CENTER FOR DRUG EVALUATION AND RESEARCH

Approval Package for:

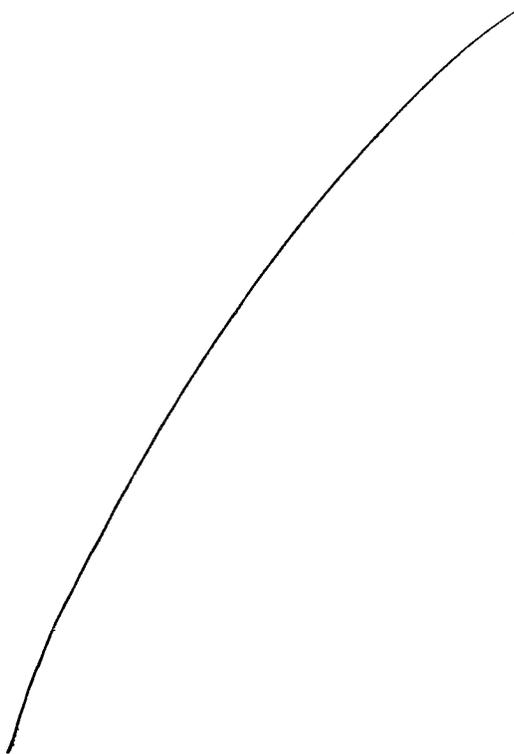
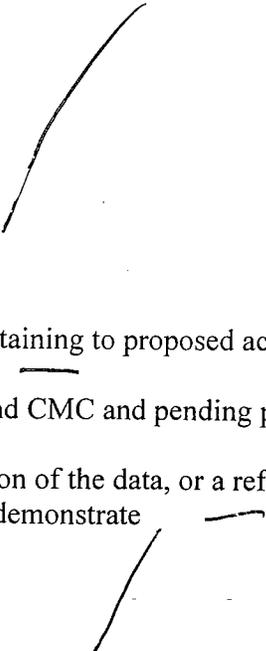
- 
39. Additional comments pertaining to proposed acceptance criteria for extractables and leachables. _____ are withheld pending responses to this letter, and CMC and pending pharm/tox evaluation of all relevant data.
 40. Provide data and evaluation of the data, or a reference to where this information may be provided in the NDA, to demonstrate _____
 41. Provide or clarify _____ where the following information may be found: extractable data for _____ which were used to manufacture batches of drug product for leachables testing.
 42. Submit revised draft labeling as shown in the attached marked up labeling. Additional labeling comments may be forwarded upon review of the response to the deficiencies listed above.
